Re: *Technical Review – Mayfair at Lawnwood*

TO: Kori Benton, Senior Planner
FROM: John R. Andrews, P.E., City Engineer 
SUBJECT: **Mayfair at Lawnwood Planned Development**
1801 Lawnwood Circle
TRC Project No. 15-42000003

Planned Development (PD) – Mayfair at Lawnwood – 1801 Lawnwood Circle

**Mayfair at Longwood
Sidewalk Map**

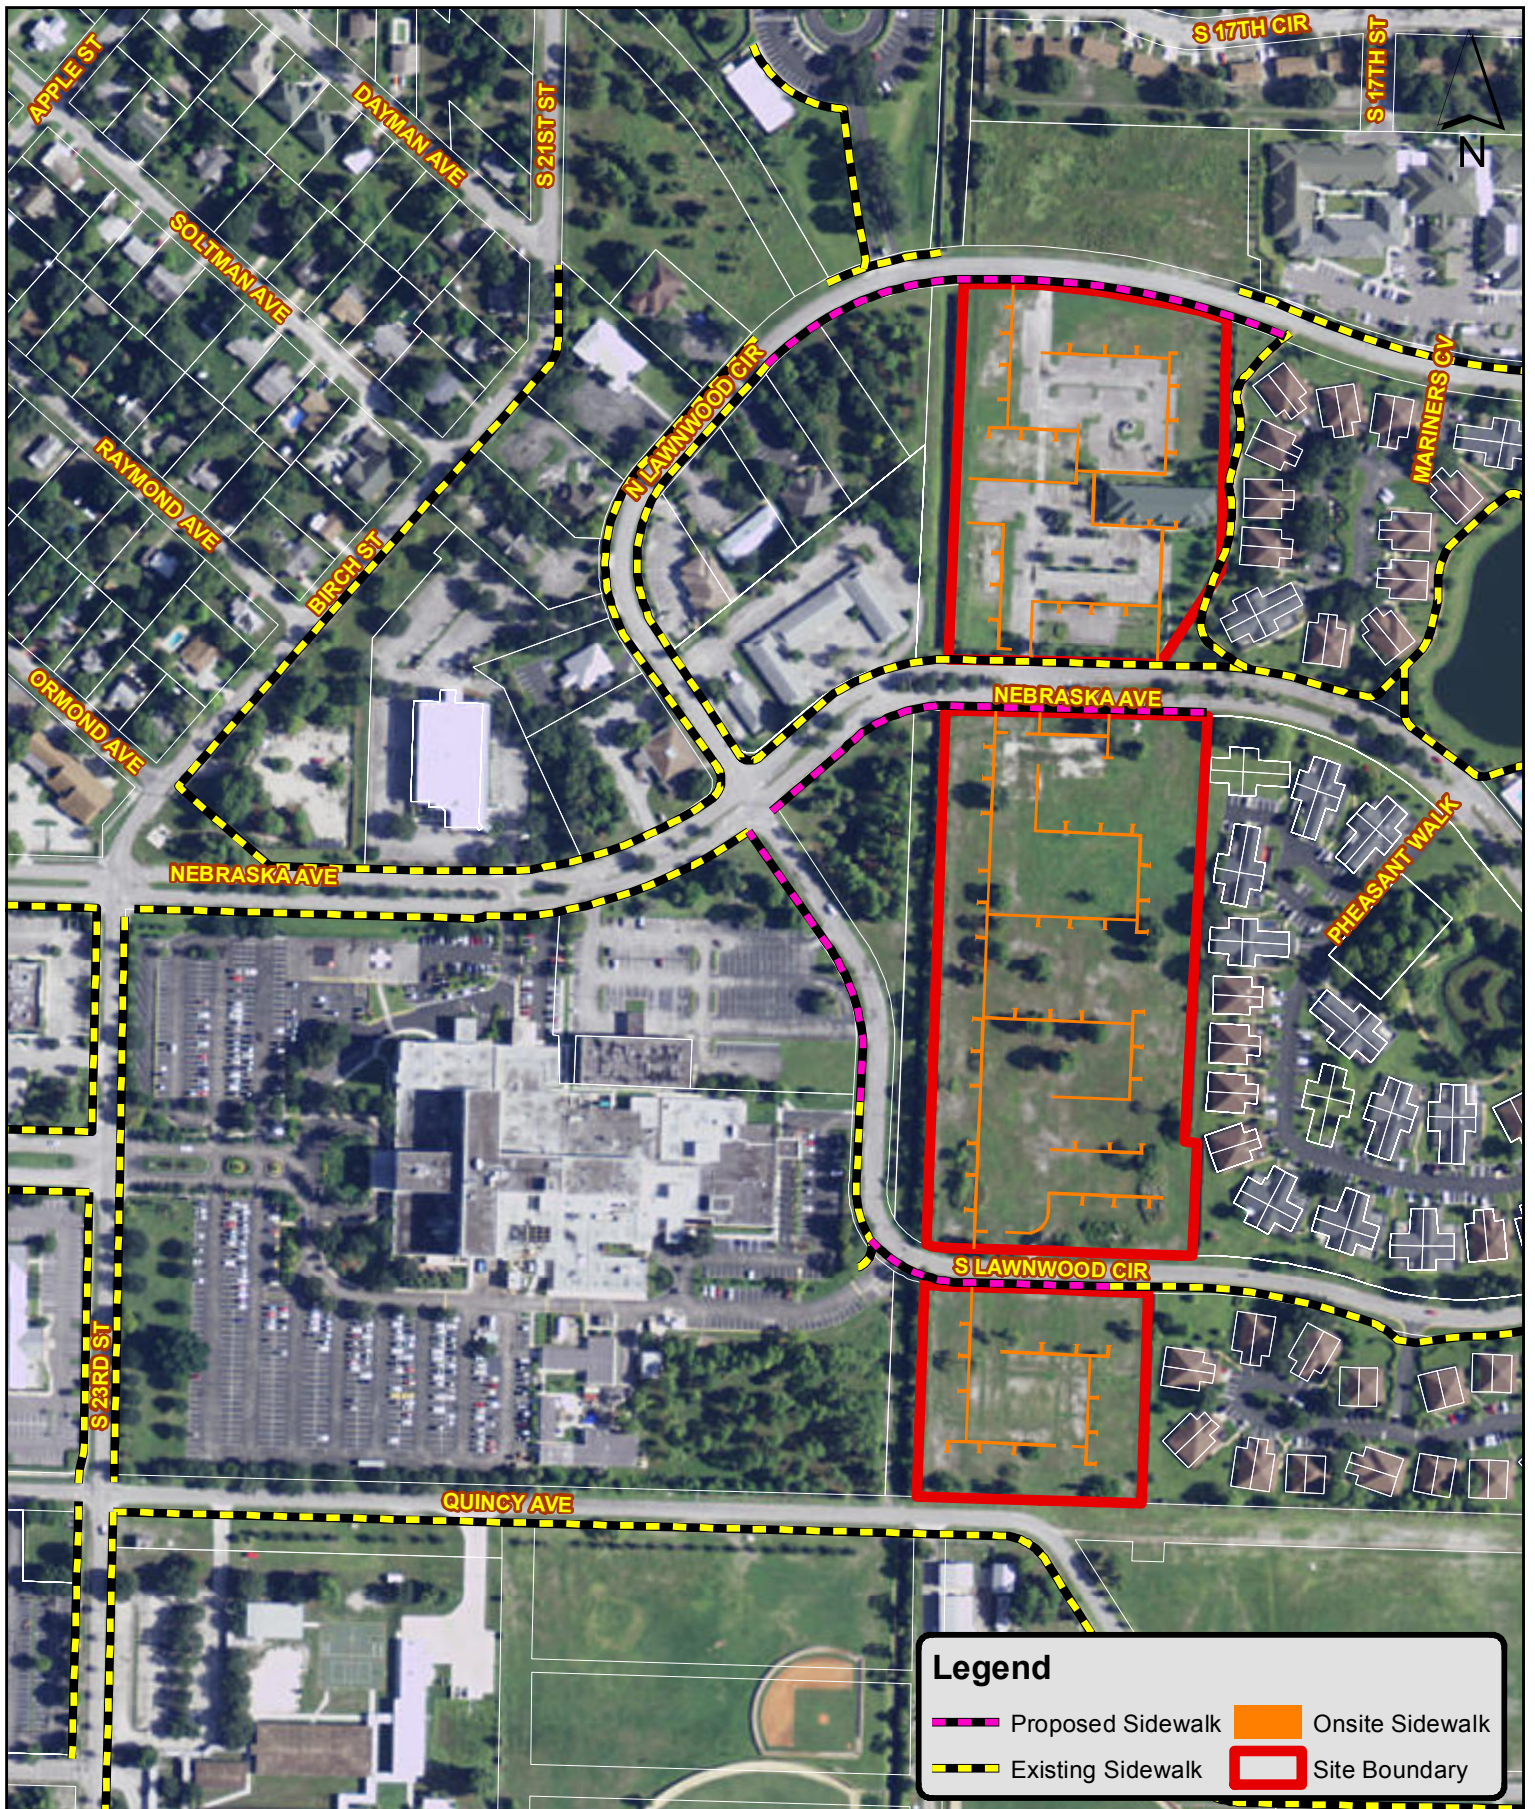
- 1) **Sidewalks:** The proposed sidewalk improvement plan provides a great opportunity to provide on-site and off-site sidewalk connectivity. In reviewing the proposed plan, it is recommended to shift the proposed sidewalk connection along North Lawnwood Circle to the southern ROW line, along the presented project, with an associated shift in off-site connections. Additionally, as Nebraska is a four lane, semi-divided, roadway it is recommended to provided a sidewalk connection along the project on both sides of the roadway. Please See Attached Exhibit for recommended adjustments/linkages.

Response: We agree. We have sent you revised sidewalk plan
